From: Skaggs, Pam
Sent: Thursday, November 20, 2014 8:40 AM
To: Fritschle, Carter
Cc: Miller, Nick; Keen, Shelley
Subject: SRBA Decree Questions - 63-311 & 63-2168 Bermensolo

In Re SRBA	)	PARTIAL DECREE PURSUANT TO
	)	I.R.C.P. 54(D) FOR
Case No. 39576	)	
	)	Water Right 63-00311

PARTIAL DECREE PURSUANT TO
I.R.C.P. 54(b) FOR
Water Right 63-02168

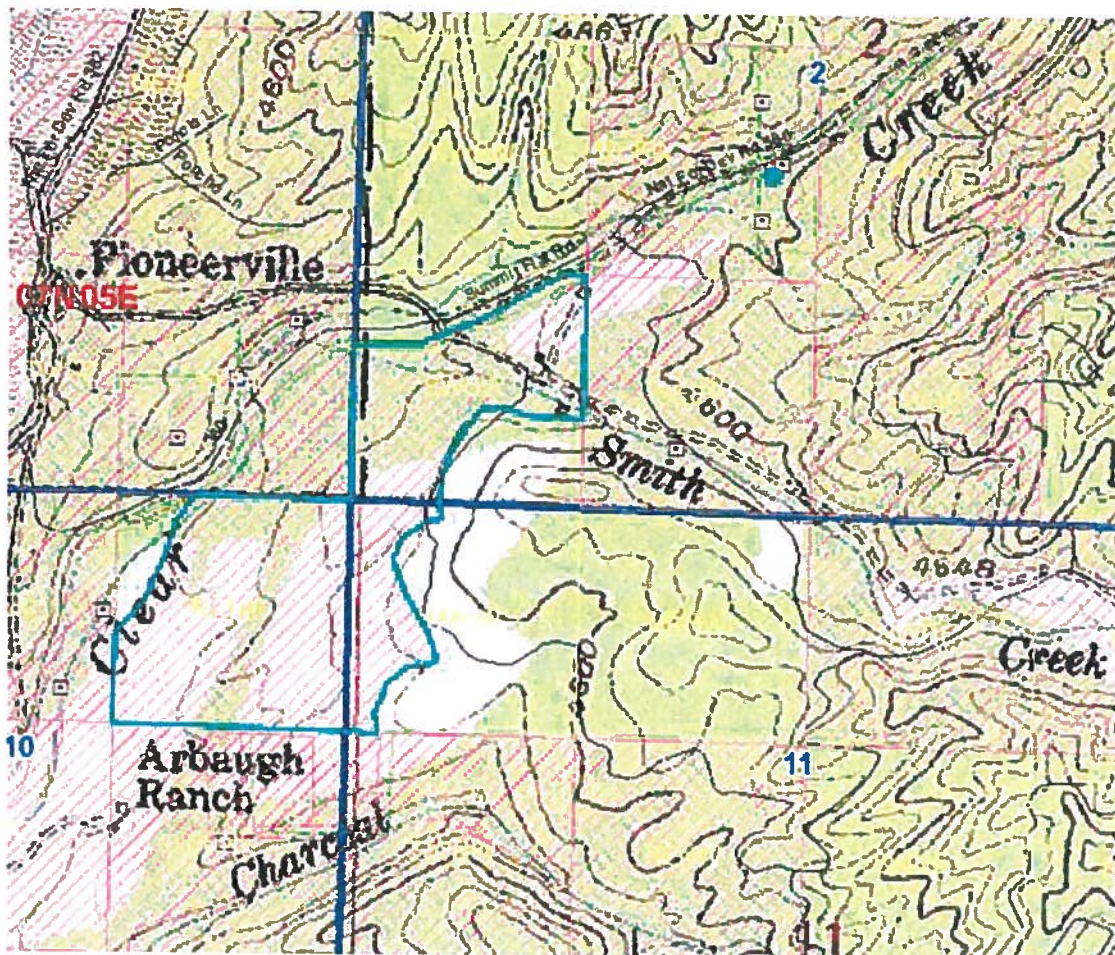
63-311 SRBA PD shows 2 PODs and Clear Creek as the source.

- **NESW** correctly shows a POD shape on Clear Creek tributary to Grimes Creek.
- **SESW** has no current shape. The described POD in the AJ Claim file is a point on **Smith Creek tributary to Clear Creek** along with 63-312A & B. Clear Creek just misses SESW. **Smith Creek is not listed a source on this PD**, but was shown on 02-20-2002 Preliminary Recommendation in claim file. The source was dropped, but not the POD? Can't add a POD shape to another source & accurately reflect the PD.

63-2168 SRBA PD doesn't have a source listed & so there is none in the database either.
Claimed source was Clear Creek, East Fork noting in remarks that the source is aka Smith Creek.
02-26-2002 Preliminary Recommendation shows Smith Creek as the source same POD as 63-311 & notes aka Clear Creek, East Fork.
No POD OR POU shapes for this right. No source identified on PD to attach the POD shape.

Looks like these two rights may need correction through the court. All we can do at this point is document the files to show the discrepancies for future reference.
